**Flood Control Project Maintenance
Levee Inspections**
LMA District Cover Sheet
Spring 2018 Levee Inspection Results

Sacramento River West Side Levee District

Spring 2018 Levee Inspection Results

Waterway	Bank	Unit Miles	Inspection Start/End	Inspector
Unit No. 01 Sacramento River	Right	49.64	03/21/2018 03/26/2018	Zach Jojola

Photo 1 of 1 : SP_2018_NA0016_435_13_20180306_00012.jpg

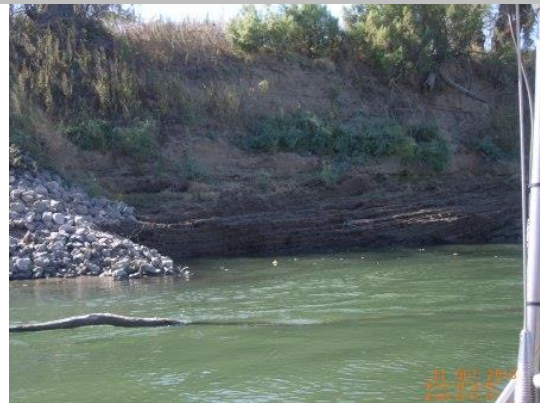
LM Start	29.96	Rating **	M	Issue No.	13
LM End	30.00	Issue Type +	Ma	Location *	WS
Category	Supplemental			GPS Latitude/Longitude	
				Start	End
Item	2015 USACE Erosion Survey, DRAFT			39.065886 °	39.066287 °
				-121.842950 °	-121.843602 °
DWR ID	DWR_NA0016_01_s _ 2018_13				
Comment Code					
Inspector Comment					
2002 - Upstream end has recent slope failure and exposure of tree roots. 2003 - Some new minor slope erosion with new snags on the bank. 2004 - Appears a little worse. 2005 - Scallop in bank at the upstream end looks worse. 2009 - Minimal new erosion, Berm width is still large, but one large event or one fallen tree and it could go fast. 2010 - New erosion, bank is nearly all vertical from slumping. Site looks bad. 2011 - Site continues to look bad. 2012 - Minor new erosion. 2015: Undermining of toe rock. [2015 Site ID: SAC_122-3_R]

Photo 1 of 1 : SP_2018_NA0016_435_17_20180306_00015.jpg

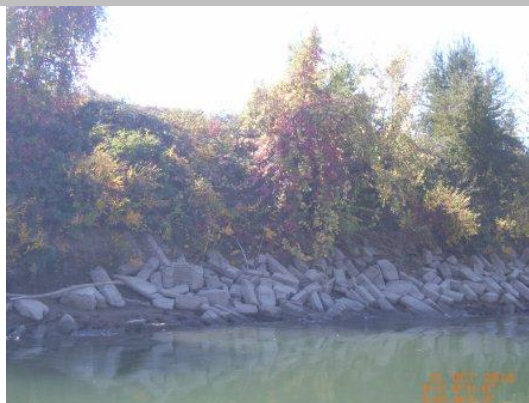
LM Start	31.43	Rating **	M	Issue No.	17
LM End	31.45	Issue Type +	Ma	Location *	WS
Category	Supplemental			GPS Latitude/Longitude	
				Start	End
Item	2015 USACE Erosion Survey, DRAFT			39.067004 °	39.066901 °
				-121.866913 °	-121.867322 °
DWR ID	DWR_NA0016_01_s_2016_17				
Comment Code					
Inspector Comment					
1997 - Erosion into the levee section; old concrete rubble loss at toe; transition between the rock upstream and the cobble downstream. 2000 - Cohesive bench with concrete slabs on top; 25 ft deep scour hole on the downstream end. 2015: No observed changes. [2015 Site ID: SAC_123-7_R]

Photo 1 of 1 : SP_2018_NA0016_435_5_20180306_00005.jpg

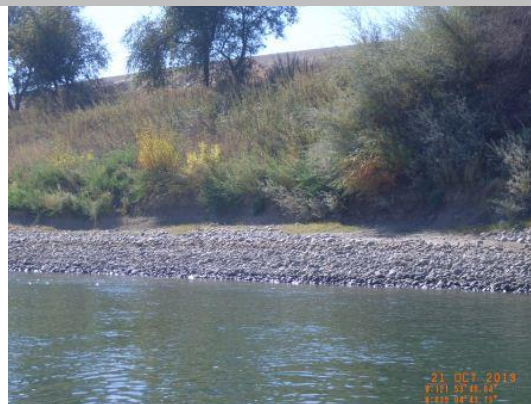
LM Start	33.29	Rating **	A/W	Issue No.	5
LM End	33.37	Issue Type +	Ma	Location *	WS
Category	Supplemental			GPS Latitude/Longitude	
				Start	End
Item	2015 USACE Erosion Survey, DRAFT			39.078340 °	39.079351 °
				-121.894656 °	-121.895317 °
DWR ID	DWR_NA0016_01_s _ 2016_5				
Comment Code					
Inspector Comment					
2008 - Slow erosion of the hard toe. 2010 - Cobble rubble is failing, erosion is into the toe of the levee, with vertical slumping. 2012 - Site appears to be relatively stable. 2013 - New animal holes. 2015: No observed changes. [2015 Site ID: SAC_125-6_R]

Photo 3 of 3 : LEVAL_SP_2018_185_1633.jpg

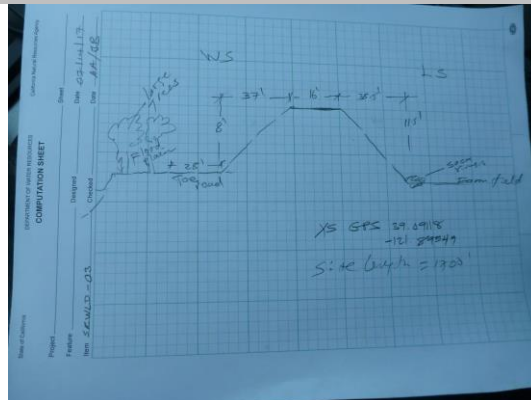
LM Start	34.24	Rating **	A/W	Issue No.	123 (cont)
LM End	34.56	Issue Type +	Ob	Location *

Photo 2 of 2 : UCIP_SP_2018_10563_17940.jpg

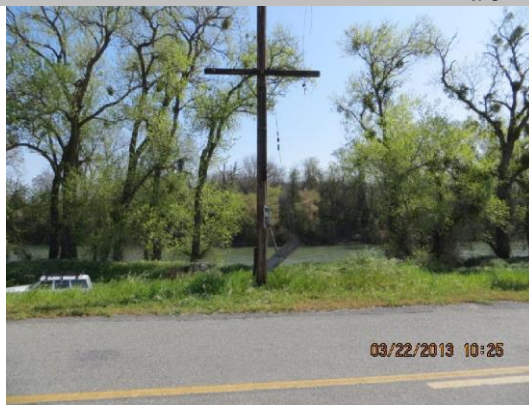
JP on WS shoulder for removed pump switch house.

Photo 3 of 3 : LEVAL_SP_2018_186_1648.jpg

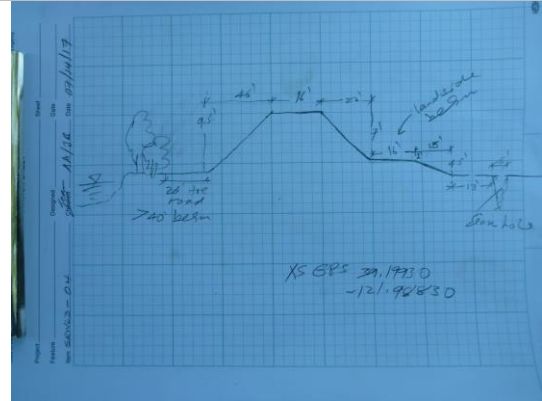
LM Start	47.96	Rating **	A/W	Issue No.	127 (cont)	
LM End	48.03	Issue Type +	Ob	Location *		
Category	Supplemental			GPS Latitude/Longitude		
				Start	End	
Item	2017 Storm Damage			39.198380 °	39.199330 °	
				-121.988603 °	-121.988197 °	
DWR ID	DWR_NA0016_01_f_2017_127					
Comment Code						
Inspector Comment						
Levee Evaluation Comments						
Description:						
Site ID No:186						
Site Designation:SRWLD-04						
Repair Type: Seepage						
Rating:Serious						
Field Date:7/14/2017						
Notes:
